CITY OF MERCED
Engineering Department

TO: Bicycle Advisory Commission
FROM: Ashley McComb Thanadabouth, PE, Associate Engineer
DATE: February 28, 2017
SUBJECT: Highway 59 Multi-Use Pathway Crossing Project Update

PROJECT NO. 115047
ATPL (045) STATE HIGHWAY 59
MULTI-USE PATH CROSSING

Pedestrian Gate and Swing Gate installation at Multiuse Path

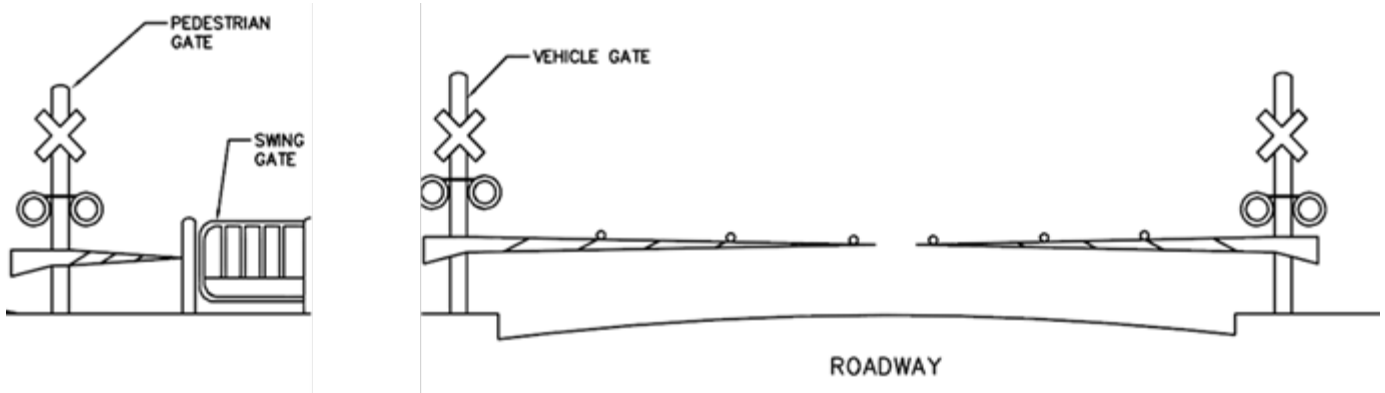
Caltrans and the BNSF Railroad had approved this configuration. However, this project is subject to review and approval by the California Public Utilities Commission (CPUC). During the review by the CPUC Engineer, the originally proposed pedestrian crossing arms are now not being recommended. Railroad flashers and bells are still proposed at the multi-use pathway crossing. It should be noted that from a safety perspective the CPUC Engineer stated that the pedestrian crossing arms are not needed.

The reason for this change is the concern that a pedestrian or bicyclists could become trapped in the rail area when the crossing arms are down. If pedestrian crossing arms are proposed, CPUC standards require the installation of swing gates within the pathway. Please refer to the exhibit below:

If installed, the swing gates will permanently constrict the width of the multi-use path for the vast majority of the pathways use (i.e. time when a train is not present). Staff believes that the swing gates pose an increased risk to pathway users, particularly bicyclists at a higher speed, and diminishes the intent and purpose for constructing the multiuse pathway.
